SECOND AND THIRD READING SUMMARY SHEET

ZONING CASE NUMBER: C814-2018-0121 - 218 South Lamar

ZONING CHANGE REVIEW SHEET

CASE: C814-2018-0121 -- 218 South Lamar

4-Lane Divided, 60' Curb-to-Curb
Back-of-Curb Condition F
Barton Springs Road to Riverside Drive

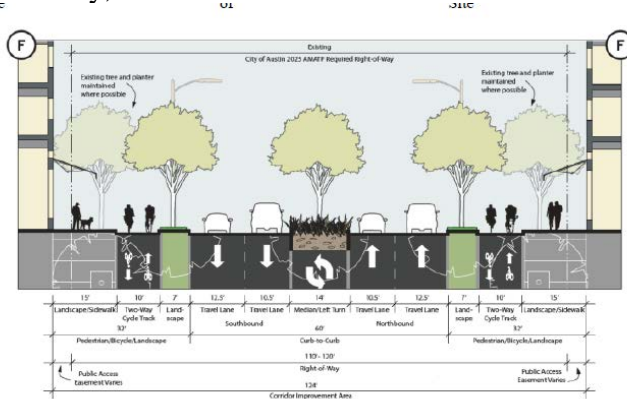
TR2. Include the below streetscape in the land use plan. Contact this reviewer for a more legible copy of it if necessary. This project is adjacent to a street that has been identified in Austin's Corridor Mobility Program (S Lamar). The sidewalk and bicycle facilities shall comply with the required cross-section at the time of the site plan application. The cross section that will be required is shown below. Find additional information about the Corridor Mobility Program here: <https://data.austintexas.gov/stories/s/Corridor-Mobility-Program/gukj-e8fh/>. Any proposed curb relocations on S Lamar requires coordination with the Corridor Planning Office and Bicycle Program. The cross section will include a 7' planting zone with street trees, a 10' two-way cycle track, and a 15' clear zone all behind curb. Additionally, a protected intersection will be required at Toomey, to be reviewed at the time of Site Plan.
